Object: Statement regarding the placement of a cord on the ASAP to keep it from dropping. ref: B71 AAA (only)

ASAP Year 2014 ref =B71 AAA

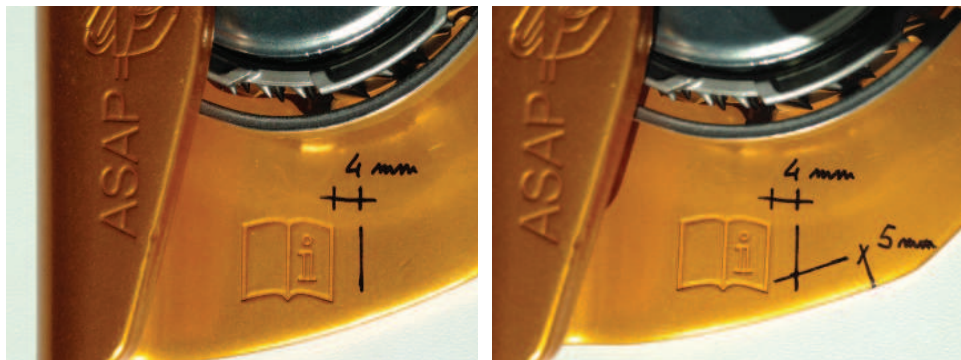
1/ With a ruler, measure the distances of 4mm and 5mm and place a mark.

2/ Using the tools below..

3/ ..Punch the mark to drill precisely. Drill a 4mm hole.

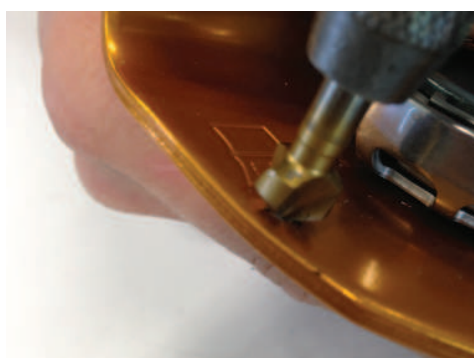
4/ Countersink both sides of the hole.
